The Following information is based on PCB type M12565 iss.3 The layout can be applied to other versions but the instructions below may not relate.

Revision: 1	d.c. ~ daylight ltd.	Page Size: A4	d.c. ~ daylight ltd.
QUAD 405 new non-inverting input			5 Greenacre Drive Pontprennau Cardiff CF23 8PA
8 February 2004	Drawn: K. Snook	Checked:	Tel: +44 29 20 657149 Fax: +44 29 20 657151
		Page 1 of 1

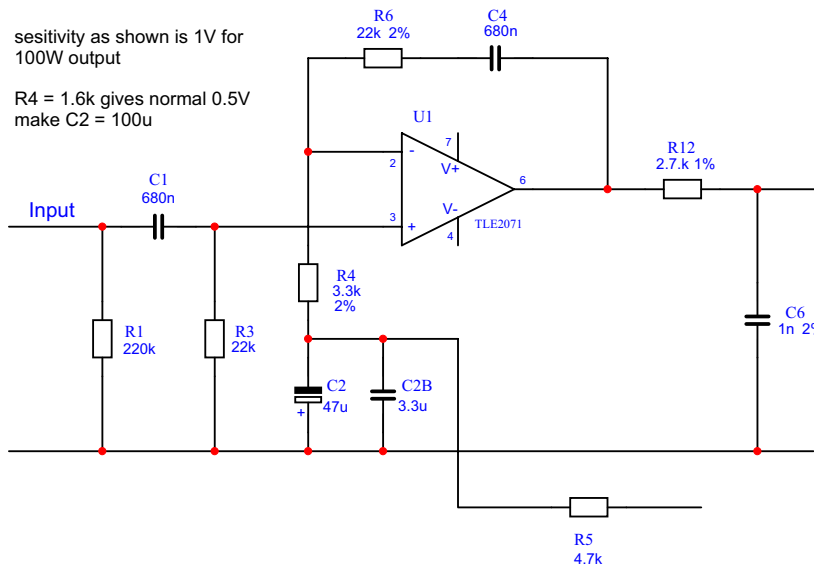
Cut track to op-amp pin 3 close to pin, remove link pins and zenner diodes D8 and D9.

Replace R10 with wire link, fit new values for R4, R6 and C4.

Fit new R3 standing upright such that it bridges R4 and fits between end of C1 and the hole to ground where the link pin was.

Fit wire link from op-amp pin 3 to junction C1/R3 this can follow a path against a ground track.

Changing R12 to 2.7k increases the frequency response to about 59kHz, this may not be suitable where the dumpers are "slowed down" in other versions of the design.
